Fig. 5M-38 COUNTERMEASURES FOR FEED WATER HEATER LEAKAGE

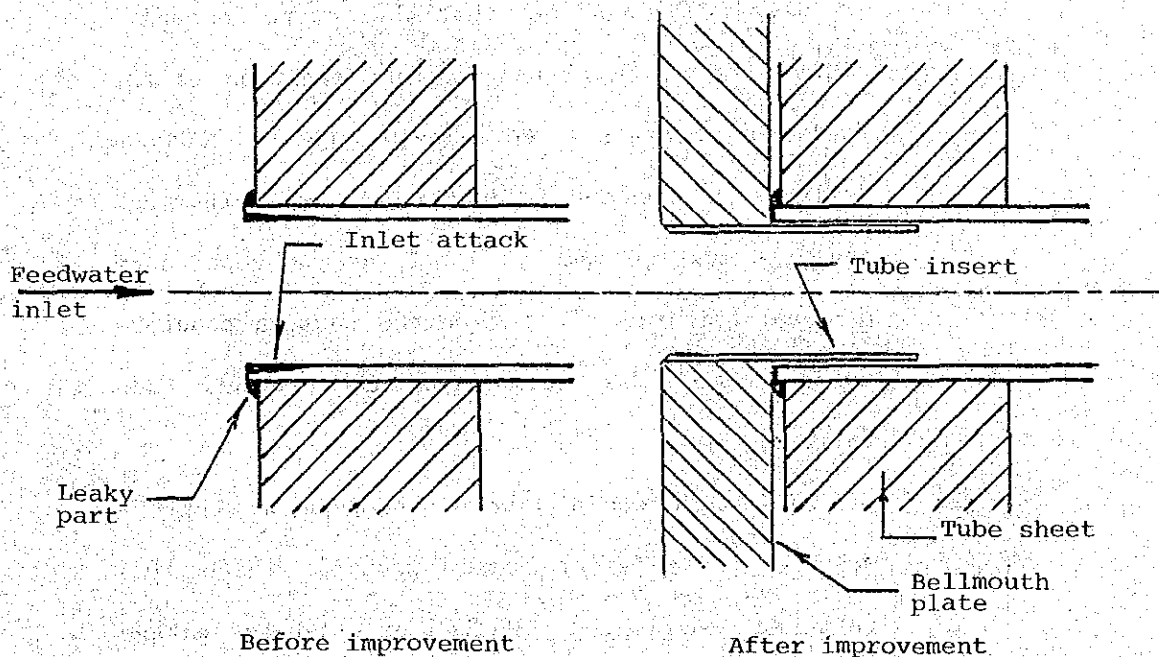
JICA team would like to propose a countermeasure on feedwater heater problems which JICA team had experienced. We had experienced leakage

of many tubes at the feedwater inlet part, causes of which are as follows:

- (i) Eddy current of the feedwater which occurs at the feedwater inlet in the water box.
- (ii) High velocity of feedwater in the tubes and solid matters in the feedwater.
- (iii) Material of the tube and method of preservation to prevent corrosion during unit shutdown.
- (iv) pH, temperature, and dissolved oxygen of feedwater

A straightening vane of the bell-mouth type and stainless steel insert in the feedwater inlet of tubes are installed sometimes.

Fig. 5M-39 CONDITION OF PLUGGED TUBES OF HOUSE SERVICE CLOSE CYCLE HEAT EXCHANGER FOR M-1
 (Number of Tube 2040)

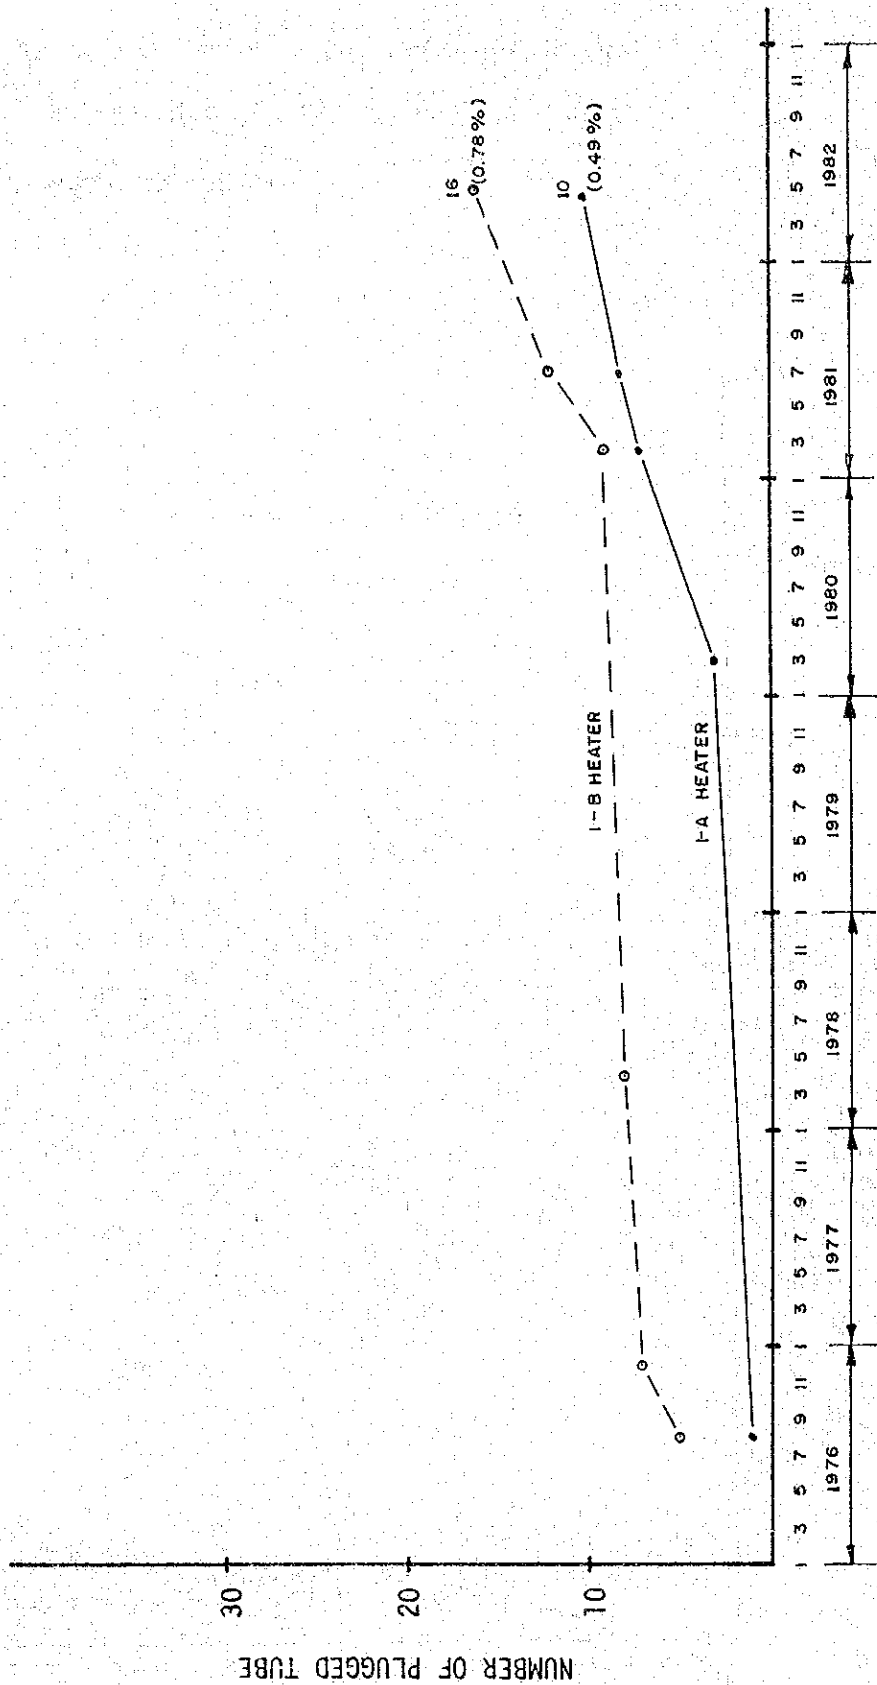
(i) The total number of plugged tubes are few.

For the A-side there are 10 pcs. (0.49%) plugged tubes while for the B-side, there are 16 pcs. (0.78%) plugged tubes as of May, 1982.

(ii) Since Feb. 1981, the rate of the number of plugged tubes has increased gradually. Hence inspection of the heat exchangers must be carried out occassionally.

(iii) In M-1, two (2) 100% capacity Heat Exchangers are in service. If trouble occurs in the existing set-up, the unit will be forced shut-down, as there are no more spare heat exchanger. However, if additional heat exchanger is installed, a spare heat exchanger would be available.

- (i) To provide a new heat exchanger with a bigger capacity unit for M-1. In M-1, two heat exchangers are in service since 1975 when the unit was placed in commercial operation. The capacity of the heat exchanger is insufficient. When one unit is in service, vibration and rumbling sound is experienced.

Fig. 5M-40 CONDITION OF PLUGGED TUBES OF HOUSE SERVICE
CLOSED CYCLE HEAT EXCHANGER FOR M-2

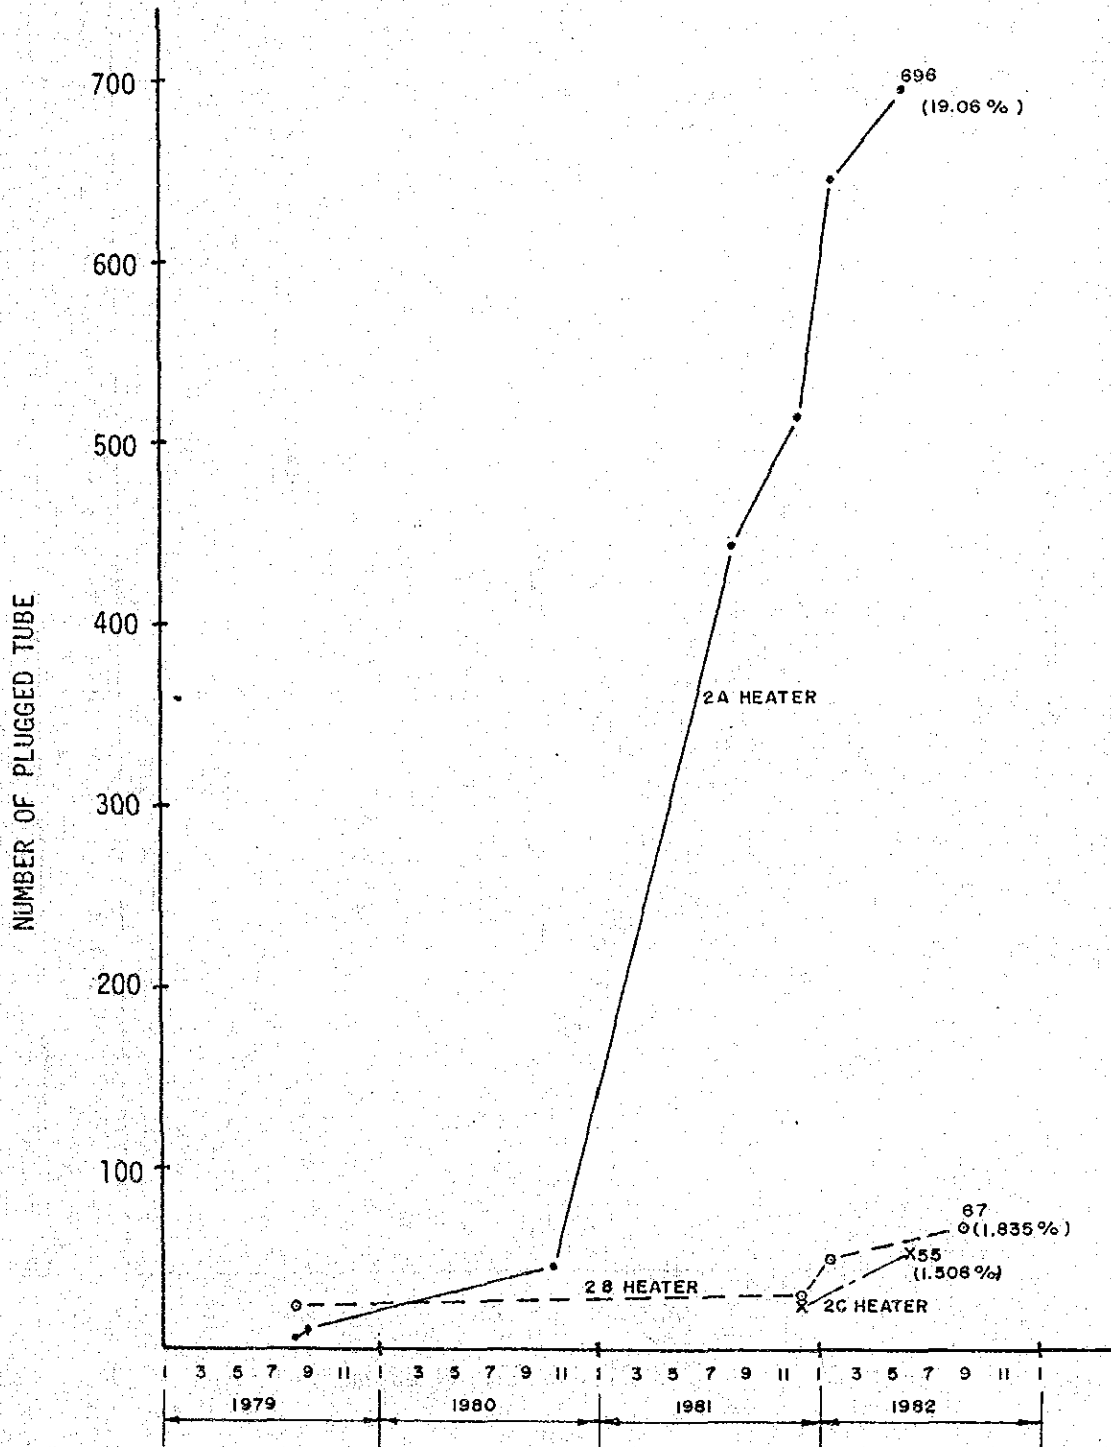
(i) As of June 1982, M-2A has 696 pieces (19.06%) total of plugged tubes.

(ii) As of Sept. 1982 M-2B has 67 pieces (1.835%) total of plugged tubes.

(iii) On M-2C the total no. of plugged tubes are 55 pieces (1.506%).

(iv) M-2A has the most number of plugged-tubes. This is one of the causes in using this heat exchanger continuously.

These heat exchangers must be serviced on a rotation basis. When NAPOCOR conducted tube plugging on the B and C side, JICA team found out that there were plenty of rust on the tube sheets, some deep corrosion of the tube sheet, and plenty of clogged-up tubes by foreign matters.

- (i) To clean all heat exchanger tubes with compressed air-jet.
- (ii) To drain the shell side of cooling water.
- (iii) To remove rust on the tube sheet by wire brush.
- (iv) Inspect tube sheet for excessive corrosion.
- (v) To weld and patch-up all corroded portion.
- (vi) To conduct hydrostatic-test.
- (vii) To plug all leaky tubes.
- (viii) To repaint tube sheet.

Fig. 5E-31 COUNTERMEASURE FOR DRUM LEVEL TRANSMITTER

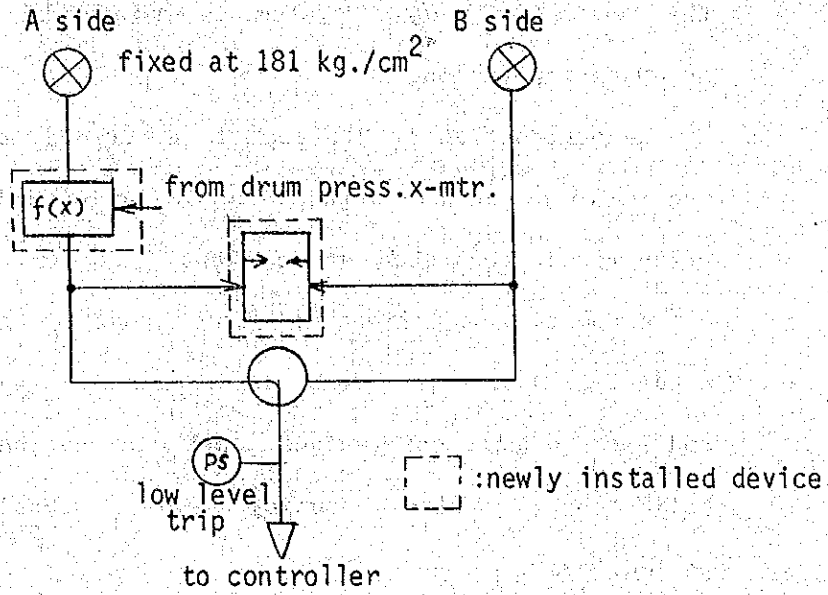
Previously, feedwater control system was on manual operation due to drum level transmitter is defective and there were occurence of drum level low trip sometimes. After taking the countermeasure recommended by utility consultant

B side has now no response, therefore it also has to be modified same as A side.

Fig. 5E-32 INSTALLATION OF TEMPERATURE RECORDER

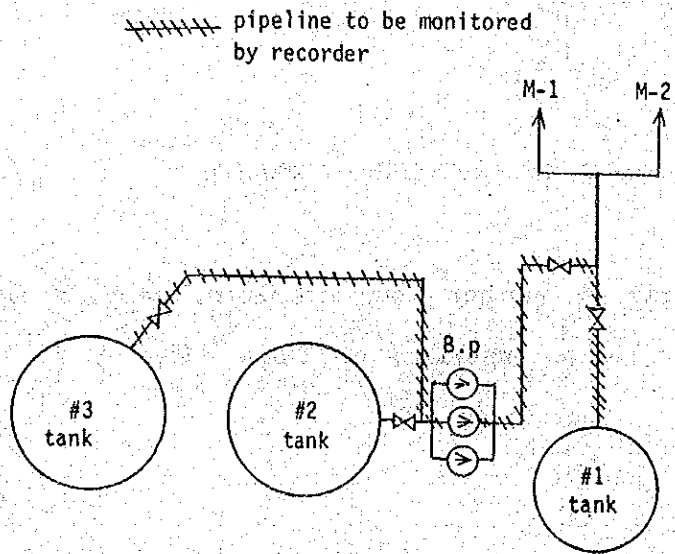
- (i) Almost all local instrument such as pressure gage and temperature indicator are out of order.
- (ii) There are no recorders of turbine speed/cam angle, condensate flow, condenser vacuum, generator output.
- (iii) There are no make-up water flow integrator and well water supply integrator.
- (iv) There was main fuel oil pump tripping after a few minutes from tank change over, because there seems to have suction filter clogging due to insufficient pipe line temperature.

- (ii) The turbine speed/cam angle, generator output, the vacuum and condensate flow recorder should be installed on the control panel for the monitoring during start-up and normal operation.
- (iii) The flow integrator for make-up water line and well water supply should be installed for management of water quantity.
- (iv) To install condenser leakage detector (conductivity meter with cation pass) for both condenser of M-1 and M-2.
- (v) To install temperature monitoring and alarming recorder on the line indicated below, and sensor should be put on the outside pipe every 50 m.

Fig. 5E-33 MODIFICATION OF COOLING

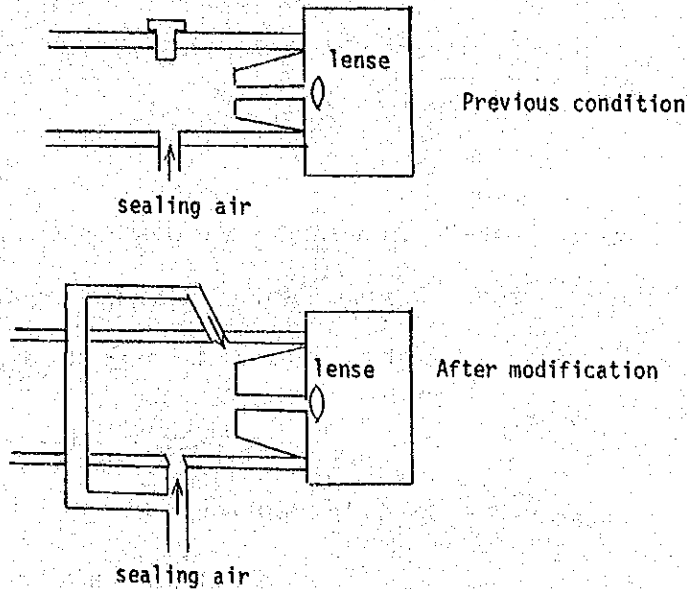
- (i) All flame detectors have been out of order.
- (ii) Countermeasures for overheating and lens misting were taken as follows but result was not satisfactory for continuous monitoring.

(ii) Cooling air system should be reviewed including capacity of flame scanner fan because air heater clogging increases furnace pressure high and less cooling air to flame detector.

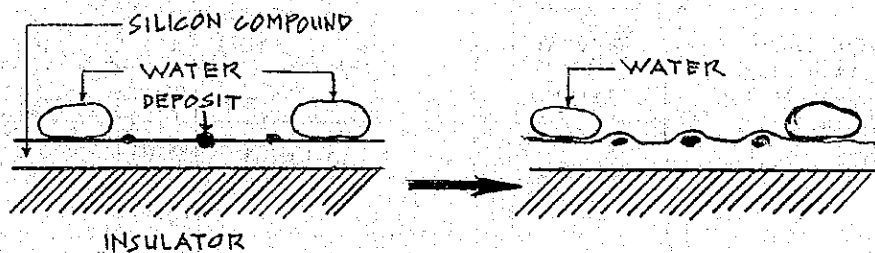
In order to prevent bursting of the lightning arresters, coating of the insulator surface with silicon compound (not silicon grease) will be effective.

Silicon compound will contribute to maintain the insulation performance of the insulator surface by the effect of amoeba action, thus deriving uniform voltage distribution of the discharging elements so that characteristic of discharge can be kept stable.

Thickness of silicon compound is recommendable to be kept between 0.5mm to 1.0mm.

Fig. 5E-34 MEASUREMENT OF SURFACE AREA

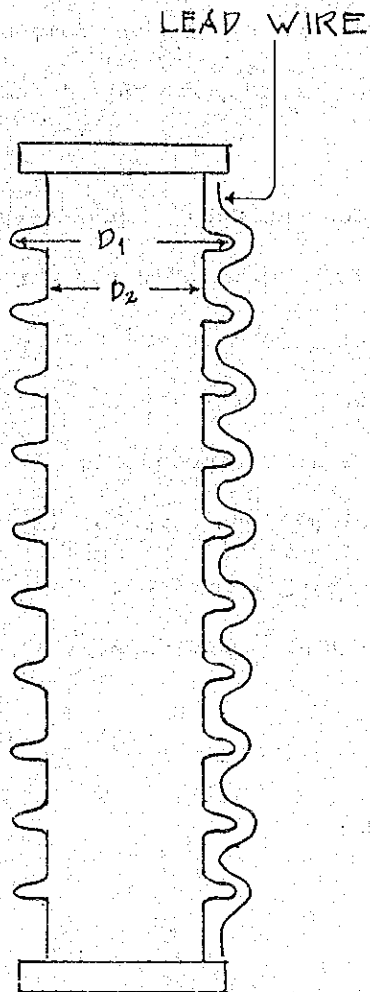
If no surface area of the insulator is given in the catalogue of the lightning arrester it can be known by the following manner.

- (1) Measure the leakage distance by lead wire L (m)
- (2) Measure the diameter D_1 and D_2 (m)
- (3) Then calculate the surface area.

$$D_m = \frac{D_1 + D_2}{2}$$

$$S = L \times 3.14 (m^2)$$
